SprintRay Inc

Declaration of Product Modifications

This is to request a Class II permissive change for FCC ID: 2A96L-SRP2304A originally granted on 06/04/2024

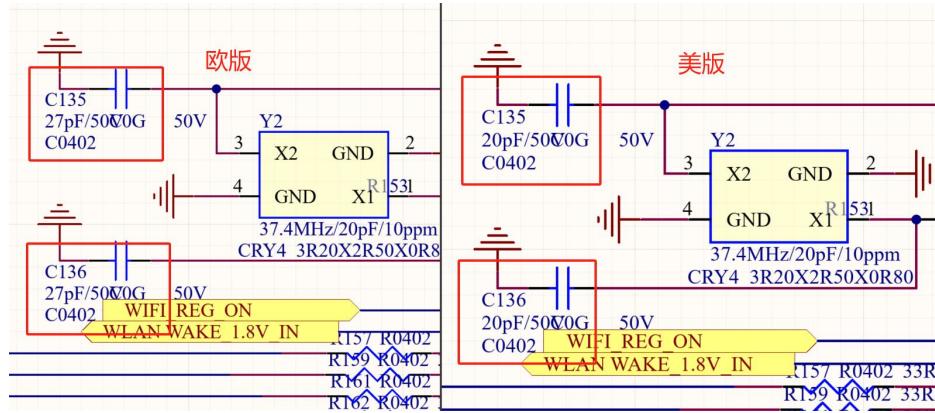
1. The P10 pin of the Ethernet connector is changed from GND to the chassis ground

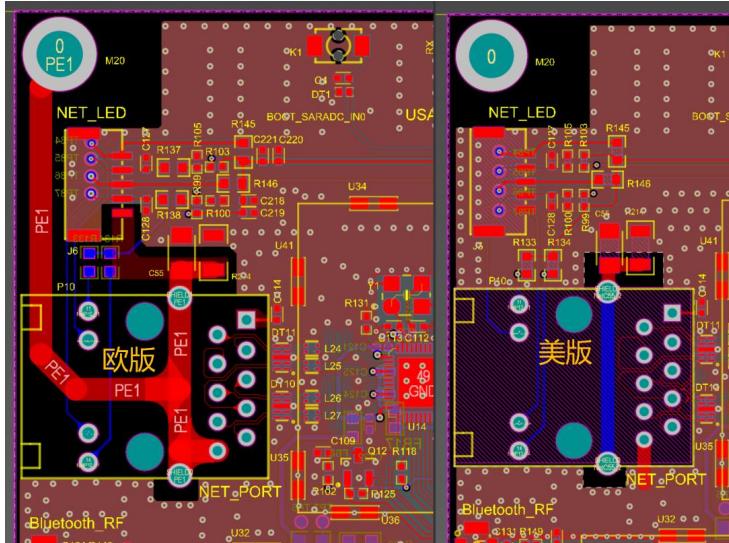
2. The capacitance values of C135 and C136 are changed from 20pf to 27pf

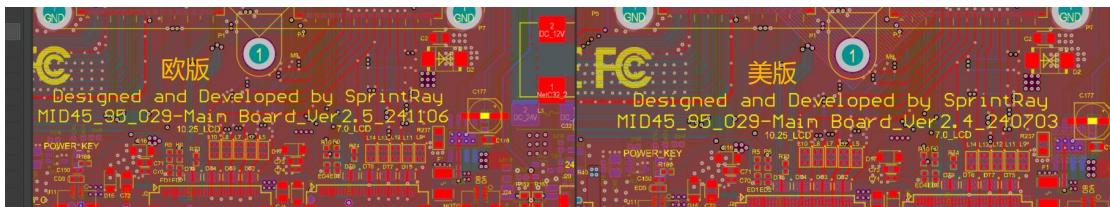
3. Ethernet connector wiring is optimized according to the schematic diagram
